Access Compliance Report

Public Rights-of-Way

Intersection ID: 46146	Main Street: ROCKY_FORD_CLUB_RD	Cross Street: BEAVER_CREEK_DR	Location: NE
ADA ID: 9338B510873F	Ramp Type: BlendTrans1	Initial Pass/Fail: Fail	Overall Compliance: No
Codes/Mitigation Info/Possible Solution		Field Measurements/Component Compliance	
Severity Score: 1.25

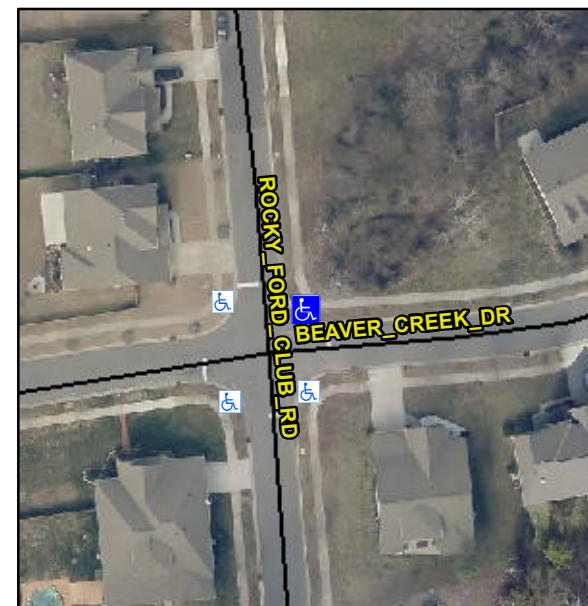
Not Found, R304.5.3

Remove & Replace Curb Ramp With Two New Directional Ramps or Equivalent.
